Vehicle Owner Notification

Subject: VON # 80- Heater/Defroster 1 Fuse Replacement

VEHICLE OWNER NOTIFICATION #80

MODEL: SAF-T-LINER HDX

FIGURE 2

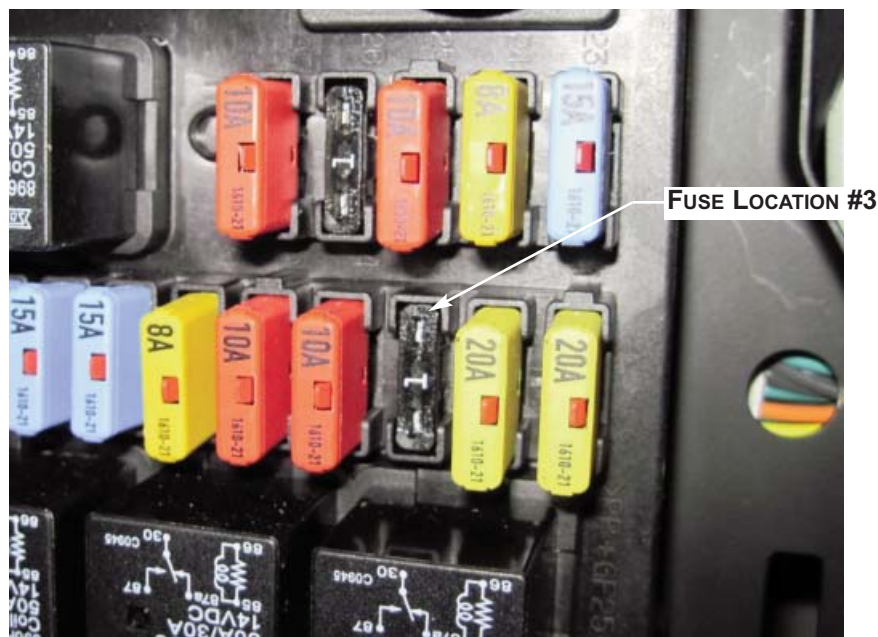
4. Locate the fuse or circuit breaker in locations #3 on PC Board #1 and replace it with a 1 amp fuse - TBB 151450. **Figure 2**
